MILITARY SPECIFICATION

SEMICONDUCTOR DEVICE, TRANSISTOR, PNP, GERMANIUM, LOW-POWER

TYPES 2N43A AND 2N44A

This amendment forms a part of Military Specification MIL-S-19500/68, dated 28 December 1971, and is approved for use by all Departments and Agencies of the Department of Defense.

FIGURE 2. Physical dimensions of alternate case outline (TO-5) for transistor types 2N43A and 2N44A.

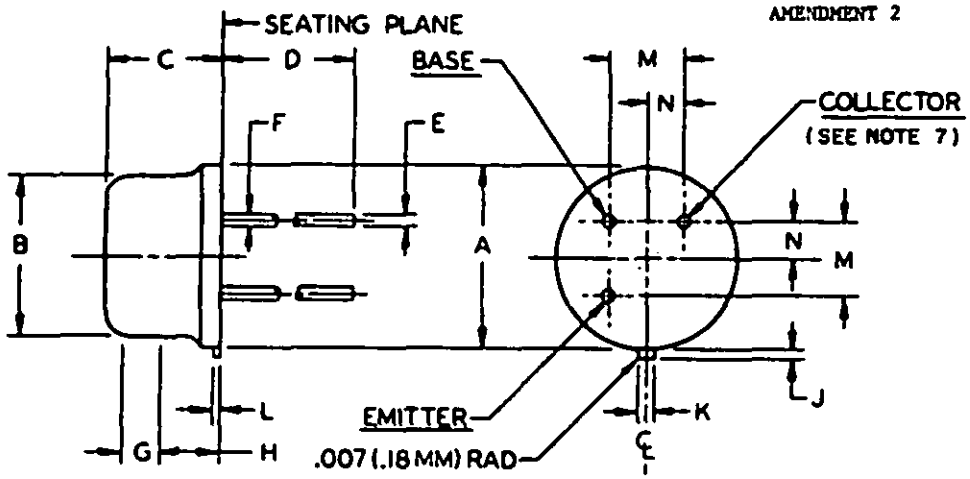
* 1.2: Delete "figure 1" and substitute "figures 1 and 2".

* 3.3, line 2: Delete "figure 1" and substitute "figures 1 or 2".

* Add figure 2 as printed on page 3 of this amendment.

"5.2 Lead configuration adapter. Lead configuration adapter MIL-M-38527/10-010 to be shipped with devices supplied in the TO-5 style case."
